I.1.b.d 926 and 932 Pandora Avenue - Rezoning Application No. 00605 and Development Permit Application No. 000508 (North Park)

E.3 926 and 932 Pandora Avenue - Rezoning Application No. 00605 and Development Permit Application No. 000508 (North Park)

Committee received a report dated November 8, 2018 from the Acting Director of Sustainable Planning and Community Development regarding a proposal to allow a 11-storey, mixed-use building consisting of residential and commercial uses.

932 PANDORA AVENUE
ROOF PLAN
A14

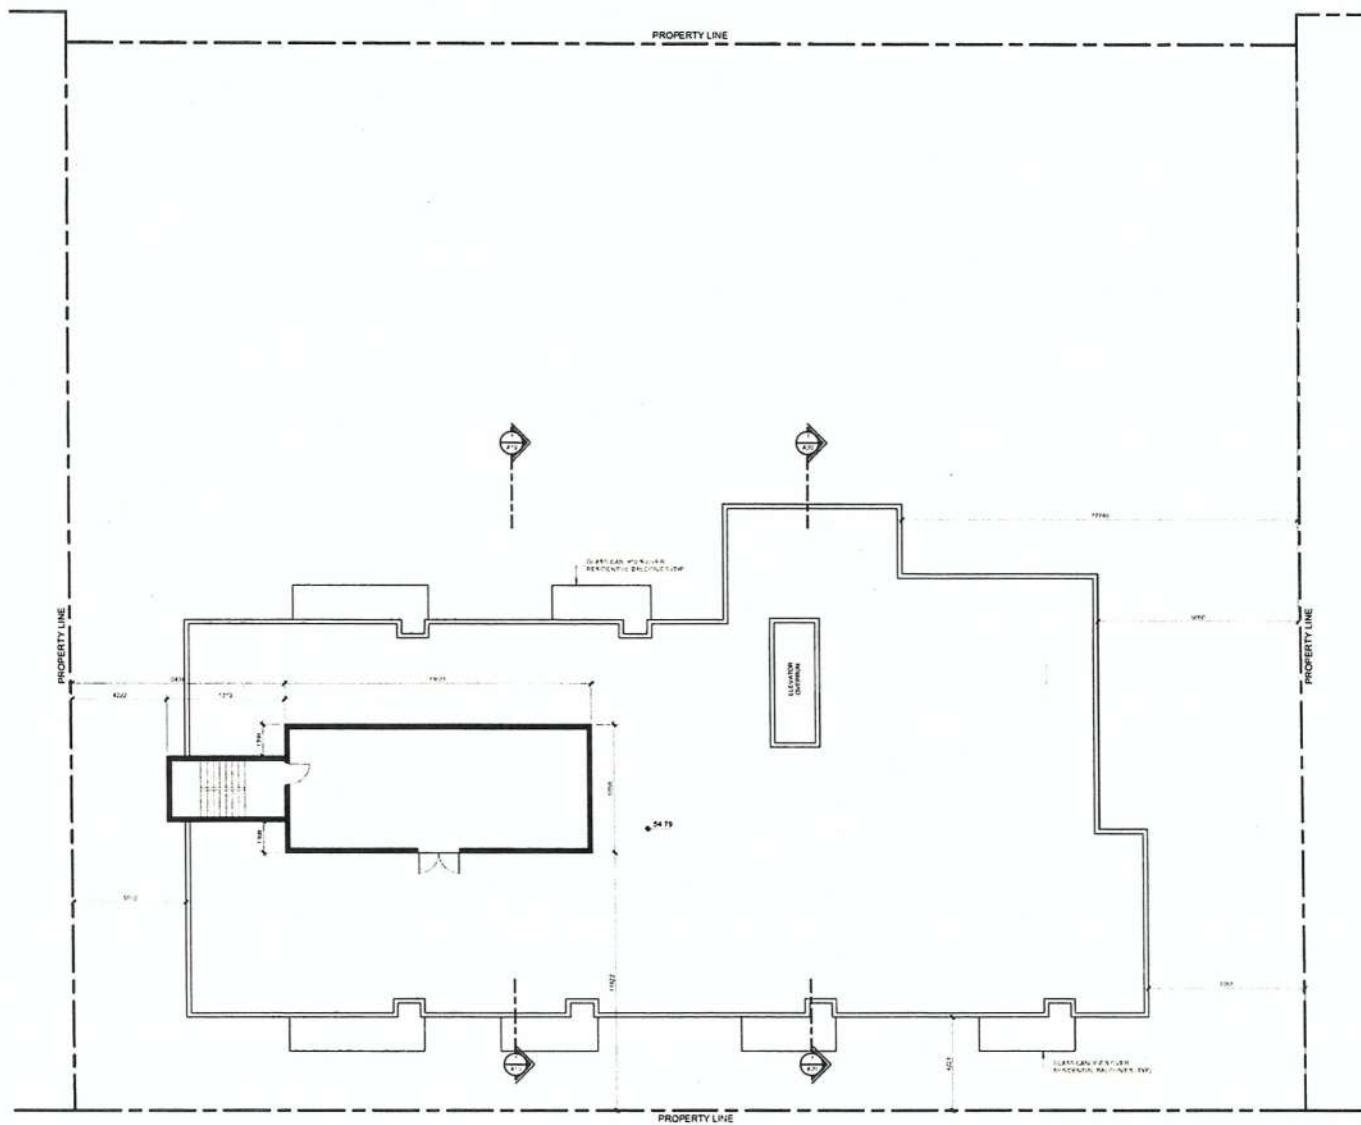
- concern for the reflectivity of the building overall; the opportunity to add materials to reduce the shininess
- need to reconsider the spandrel glass cladding

EAST ELEVATION

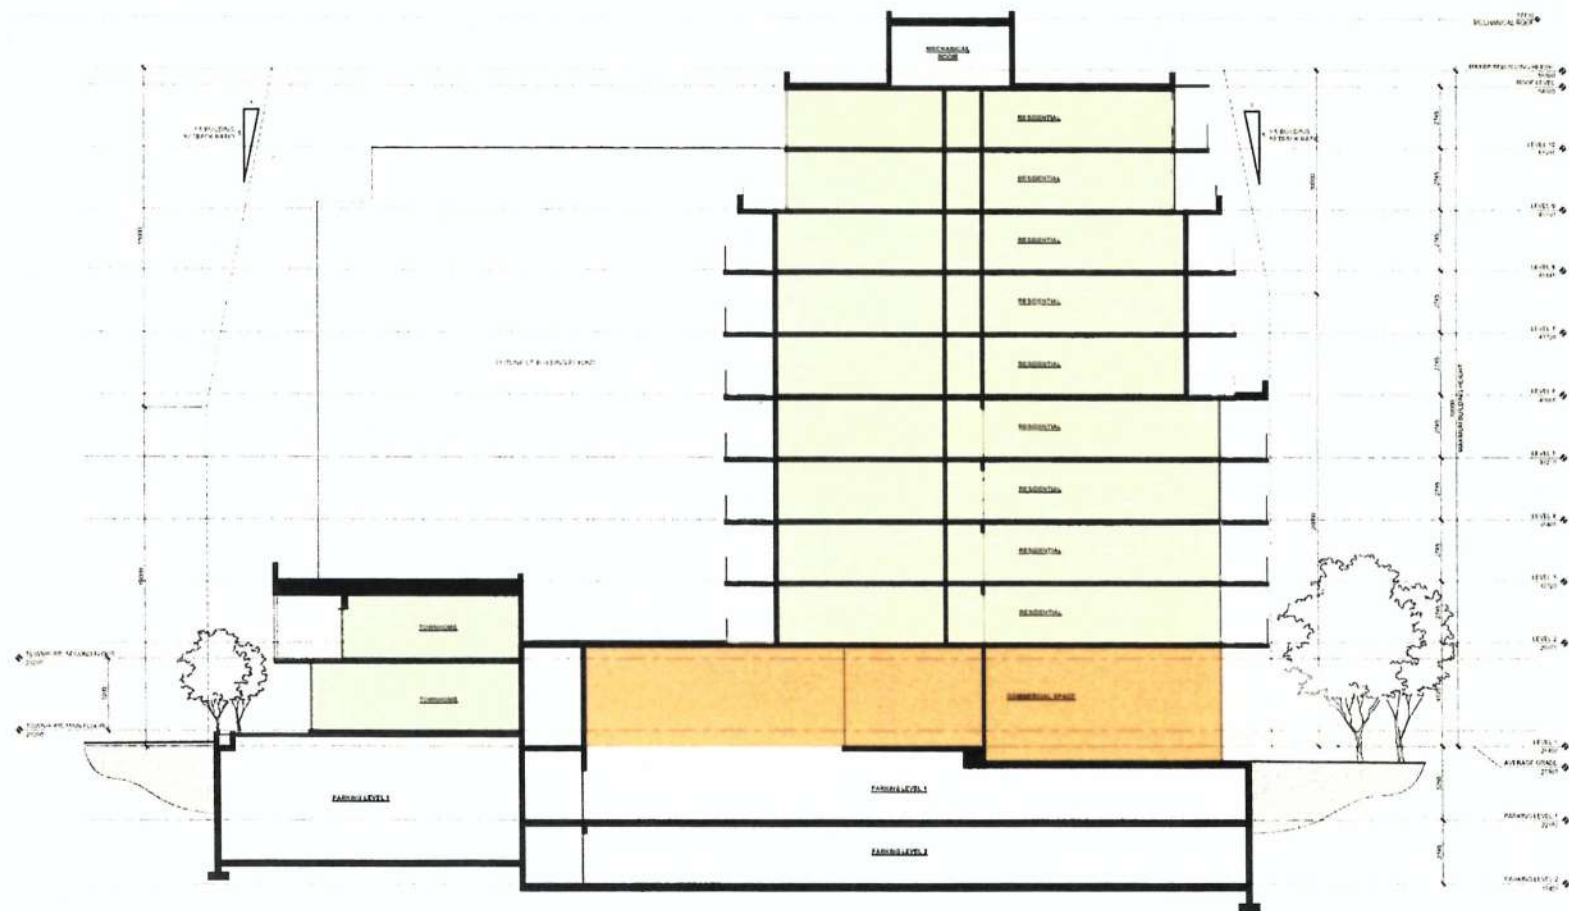
That, subject to the exploration of design revisions to soften the vertical cement panel on the north elevation of the proposed mixed-use building to the satisfaction of the Director of Sustainable Planning and Community Development, that Council, after giving notice and allowing an opportunity for public comment at a meeting of Council, and after the Public Hearing for Rezoning Application No. 00605, if it is approved, consider the following motion:

The DCAP design guidelines encourage the use of visually lighter coloured materials, excluding reflective or mirrored finishes on upper portions of the building. On the north elevation, the applicant is proposing vertical cement panel that extends up to the eighth storey. To break up this relatively blank façade treatment, the applicant has added some horizontal fins and windows; however, staff still have concerns related to the “heaviness” of this element in relation to the other exterior materials above the second storey and note the addition of windows or other architectural elements may be one approach to break up this section of façade. The wording in staff’s recommendation encourages the applicant to further explore some options to soften the vertical cement panel prior to public hearing.

- Large areas of spandrel panels has been revised to cementitious cladding as per bubbled locations on elevations.

- The balcony on the 9th floor has been modified to be a combination of cementitious cladding on parapet wall, full-height glazing, and a combination of glazing and solid parapet. Refer to bubbled location noted on elevations.
